INFORMATION REPORT

4 April 1951

German Experts' Analysis of the Alleged Soviet "Turtle Tank"

Engine between driver and rear gumner

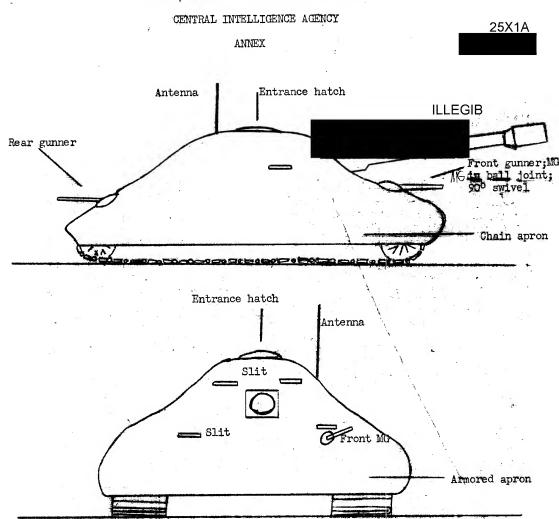
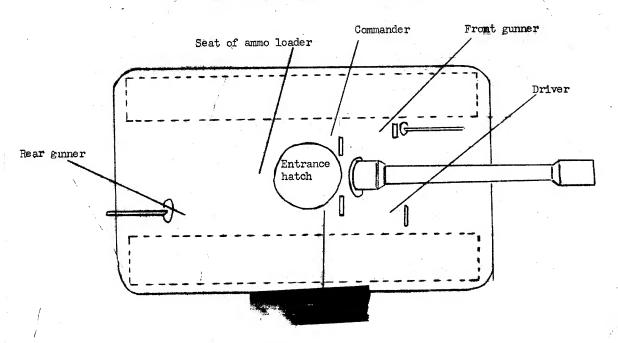
point out that the informant must have been a rank amateur on the question of armored vehicles. The drawing shows characteristics which are inconsistent with modern tank warfare, such narrow tracks, covered front wheels, which woul ability, and a poor height:width ratio. They compossible, since such a vehicle would not be suitable for transport by the Soviet rail system; even a maximum width of 3.30 meters would permit transport only in one-way traffic. A ratio of height and width of 1:1, as indicated in the sketch, is considered as presenting too many vulnerable angles; a ratio of 3:2 would fit the known "Turtle Tank". They mention, en passant, that the known "Turtle" permits a gun deflection between eight and ten centimeters which is contrary to the description. When the recoil-counter-recoil mechanism and recoil break were drawn in on the sketch, there was very little space left for the engine, driving gear, gas tank and crew. Hence, the vehicle would not be able to carry much ammunition, would have a short action radius and, because of the necessary clumsy firing operation, would have a long firing interval.

conclusion. consider the vehicle on which the report is gun which, because of its shape, we able to eads and on the vertical surface of the not with a type weapons. They believe that
